Project	<b>IEEE 802.16 Broadband Wireless Access Working Group</b> < <a href="http://ieee802.org/16">http://ieee802.org/16</a> >	
Title	Consolidation text for ANNEX in 16h WD	
Date Submitted	<del>2006-04-30</del> 	
Source(s)	Jim Carlo, Wu Xuyong Huawei Huawei Industrial Base, Bantian, Longgang, Shenzhen 518129 P.R.C	Voice: +86-755-28972324 Fax: +86-755-28975523  <a href="mailto:j.carlo@ieee.org">j.carlo@ieee.org</a> , <a href="mailto:wuxuyong@huawei.com">wuxuyong@huawei.com</a>
Re:	80216h-06_011: Working Group Review: P802.16h Working Document (2006-04-07)	
Abstract	Editorial and clarification text on current ANNEX B&C	
Purpose	Clarify the current ANNEX text	
Notice	This document has been prepared to assist IEEE 802.16. It is offered as a basis for discussion and is not binding on the contributing individual(s) or organization(s). The material in this document is subject to change in form and content after further study. The contributor(s) reserve(s) the right to add, amend or withdraw material contained herein.

## 1 Annex B

## 6 interference scenario case study

14 **Figure h-B1—GPS 1pps Pulse**

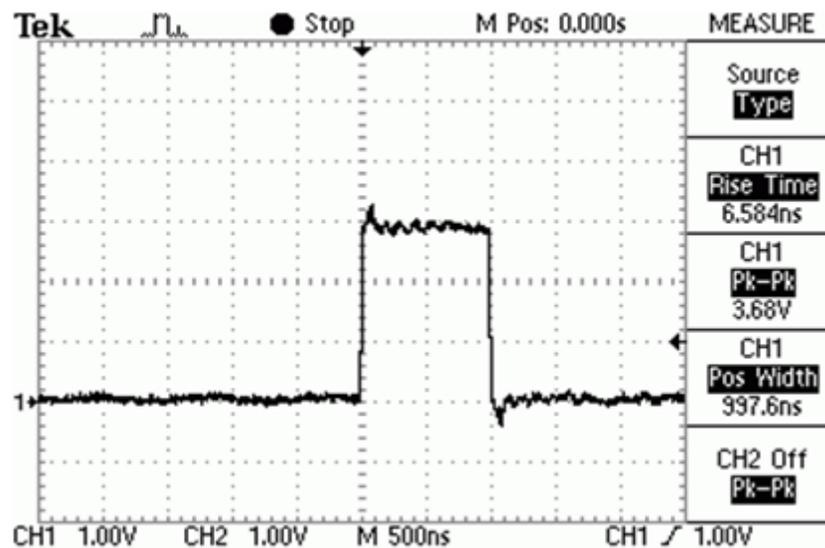
9 ~~The Every B~~base stations equipped with a GPS receiver ~~are would be~~ capable of receiving a UTC synchronized 1 pps  
10 timing signal. The ~~accuracy of the~~ clock pulses derived from ~~a using~~ GPS ~~receiver~~ are accurate to +/- 100 usec and the  
11 ~~derived~~ pulses ~~that are derived~~ typically have rise times within +/- 2.5 nsec. Fig 1 shows a typical GPS 1 sec pulse and its  
12 duration (Trimble Inc. Palisade output).

10 **Figure h-C1—Environment of initializing basestation**

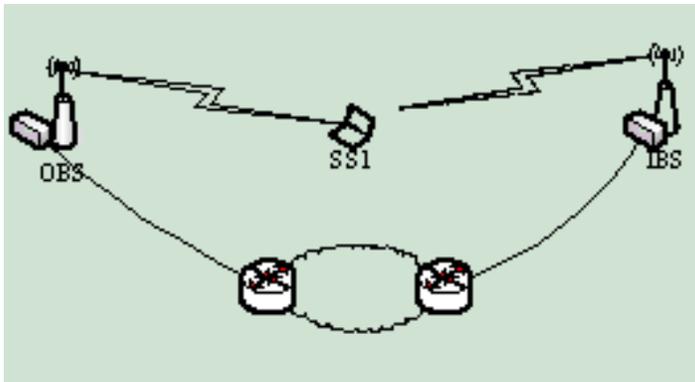
11 Suppose OBS and SS1 ~~are~~ part of an operating network, SS1 has ~~ve~~ a stable air link with ~~OBS~~ it's BS before IBS  
 12 ~~start,~~ and OBS has ~~ve~~ a wired link. Now ~~assume that the~~ IBS comes into this area ~~and already has a wired with wire~~ link ~~to~~  
 13 ~~the core network,~~ IBS could contact OBS if he knows the IP address of OBS., ~~U~~ Unfortunately ~~IBS~~ it does not know  
 14 ~~OBS's~~ the IP address and ~~probably~~ there may be no regulatory server to ask for help. Notice ~~also that here,~~ the IBS will not  
 15 have any SS attached before IBS itself has finished initialization. ~~Based on list of assumptions referred to the working~~  
 16 ~~document, we can study on cases IBS is in and what kind of problems it may meet.~~

**Figure h-C4—case 1x study**

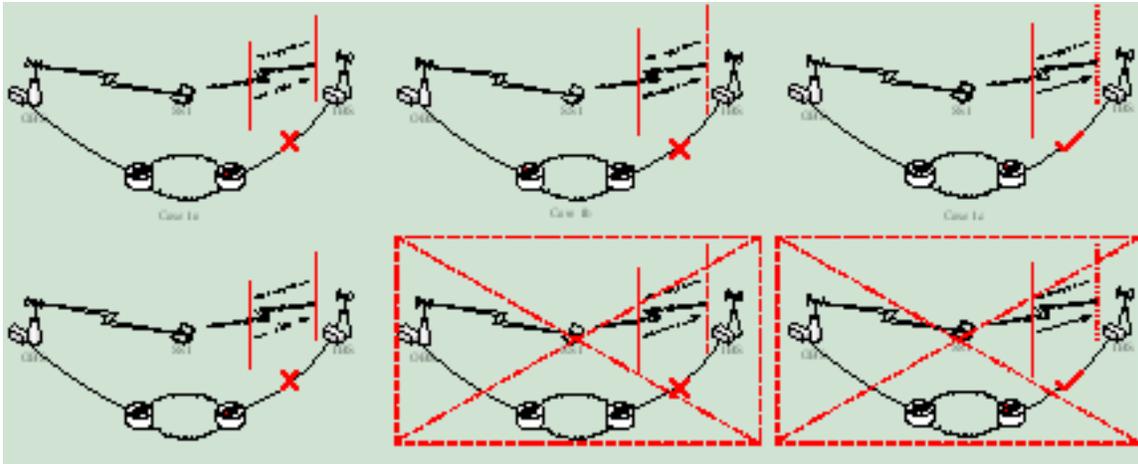
*[Note: although logically case 1b and 1c could happen, these cases are not normally exist, because the channel propagation are symmetric in both direction, but the BSs' transmission power are normally higher than the SSs'. So when the IBS couldn't been detected by SS1, the IBS will not detect SS1's signal also.]*

In these cases IBS doesn't interference with SS1, which means that the OBS's network does not need to contact the is not necessary to contact IBS. This Case 1x is not a So case 1x(1a/1b/1c) are not the target initialization scenarios for WirelessMAN-CX base station in 16h.

**Figure h-C5—case 2x study**

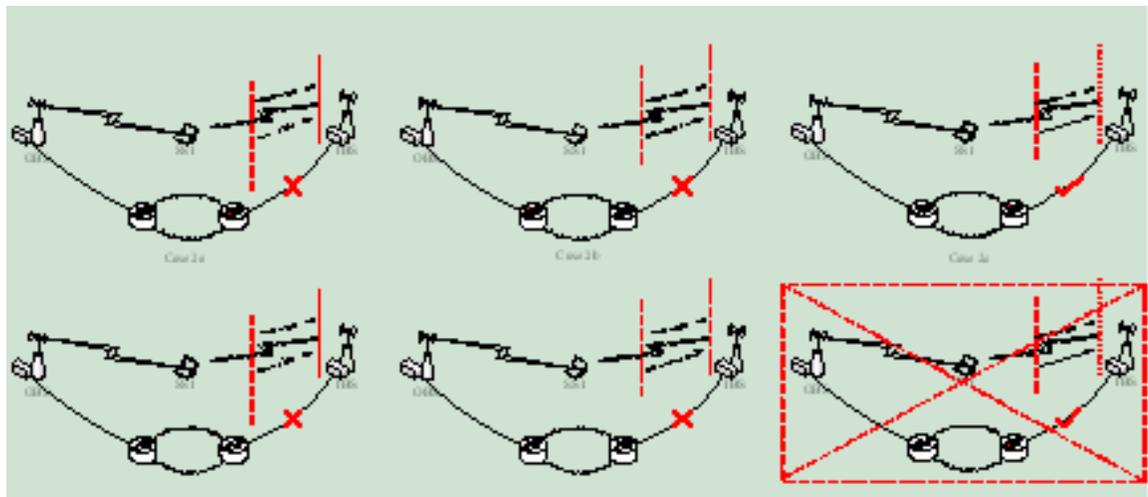
*[Note: case 2c normally doesn't happen for the same reason with case 1b & 1c.]*

In case 2x, these cases, IBS's signaling may could be detected by SS1, but SS1 cannot not decode the signaling. The problem here is, IBS may interfere to SS1, but SS1 can not identify + know who is the interferer, so SS1 it caean not inform tell the OBS who is the interferer, so the OBS could not contact IBS for cooperation. Case 2x These cases is the worst case for WirelessMAN-CXs that 16h should deal with.

**Figure h-C6—Enhanced mechanism dealing with case 2x**

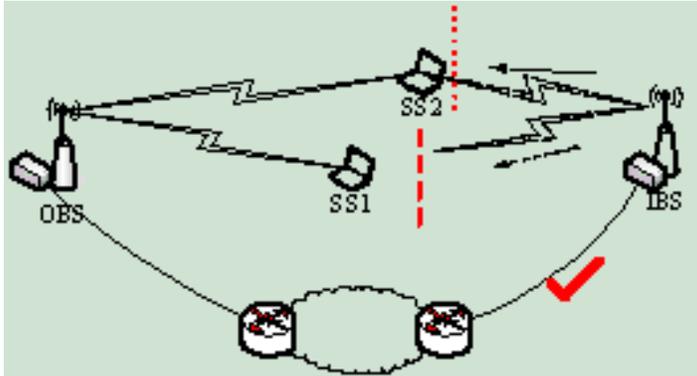
8 Some SSs (eg. SS1 in the figure h-C6) interfered by IBS can not decode the information contained in the broadcast  
 9 signaling while some SSs decode it at the same time (eg. SS2 in the figure h-C6). All these interfered SS will report to OBS  
 10 for the signaling. Dealing with all the report, OBS will try to figure out the interferer of the SSs which can not decode the  
 11 signaling by report message of other SS at the same time, and make use of the interference time/frame number inside each  
 12 report message.

**Figure h-C7—case 3x study**

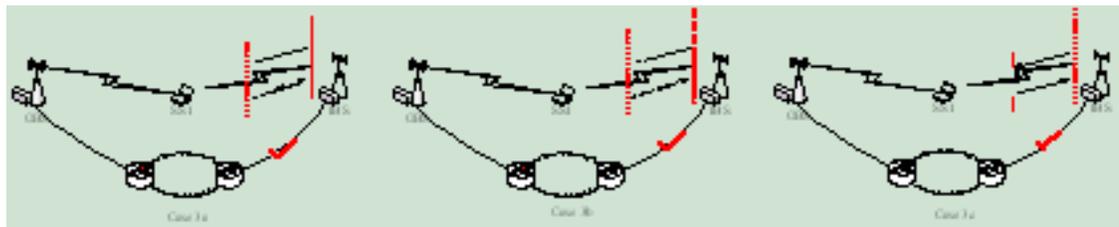
21 Case 3x is the These cases are most applicable use of WirelessMAN-CX interesting cases that 16h need to make out the  
 22 solution. The We can see each one of the 3 cases here is a normal case, and we need to deal with them all. In order to find  
 23 the common solution, we need to take the advantage of the common condition of Case3x is that -That is, SS can decode  
 24 the IBS signaling. It's understood that if we don't depends on the IBS signaling transmission, in case 3a and 3b, operation  
 25 network will not be able to find IBS in the core network. And the only way we may enable the operating network to do this  
 26 is using the SS to relay the signaling which is managed to contain the IP address information.
